## Irish Air Line Pilots' Association

### **Ref: Response to the Issues Paper CP7/2018.**

### **IALPA's S&T response to CP7/2018 "Consultation Questions"**

### 1.3 A New Terminal 3 or new Pier 5?

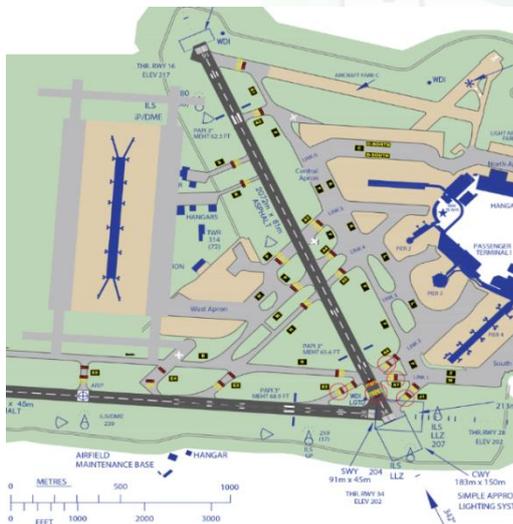
Given the foregoing we compare Dublin (DUB) to Zurich (ZRH) Airport. Both Airports had similar 2017 traffic volumes 29.6mppa /29.4mppa. Both Airports main campus are constrained by a cross runway.

However, Zurich overcame its problem by tunnelling under its cross runway to access a predominately dedicated wide-bodied satellite pier / Dock E.

IALPA therefore propose a new satellite Pier 5 perpendicular to the parallel runways. Thereafter the DAA has optional Pier 6 / Terminal 3 expansion opportunities further west. Additional benefits of Pier 5 is the ability to build "off-site" and finally integrate same with the current "operationally inaccessible" West apron.

Ialpa proposed Satellite Pier 5 above and how it would visually look, similar to Zurich satellite Dock E.
